Report: TAB Punchlist
Function: Test, Adjust, & Balance
Date: 02/18/2025
Completed By: National TAB

PROJECT
02-17-25 CULVERS ALMA, MI

- Missing dampers on RTU-2 (Kitchen)

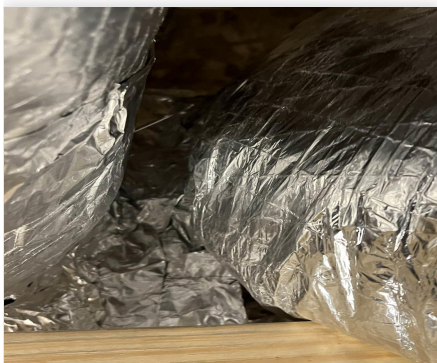
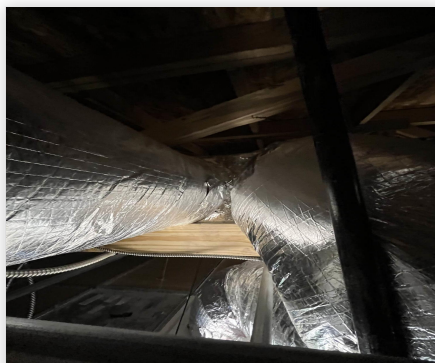
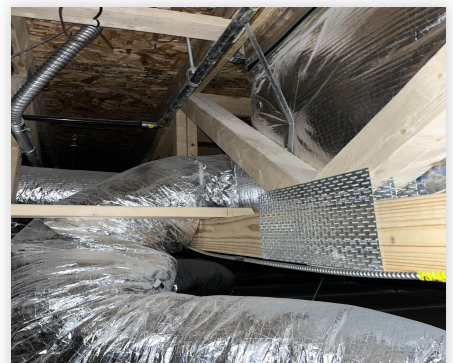
Issue Name : Missing dampers on RTU-2 (Kitchen)
Description : Diffuser 1-3,1-11,1-12 missing dampers. 1-3 is high on flow at 455/350CFM 1-11 is very high on flow at 782/350CFM unable to reduce airflow to these diffusers. Diffuser 1-12 was able to be restricted with duct straps to bring flow to design. Recommend Mechanical Contractor install dampers so these diffusers can be sufficiently balanced.
Created By : National TAB **Assigned To :** National TAB - Dylan Crisman
Status : Open
Priority : High **Asset Tag :**
Originated Date : 02/18/2025 - Dylan Crisman - National TAB
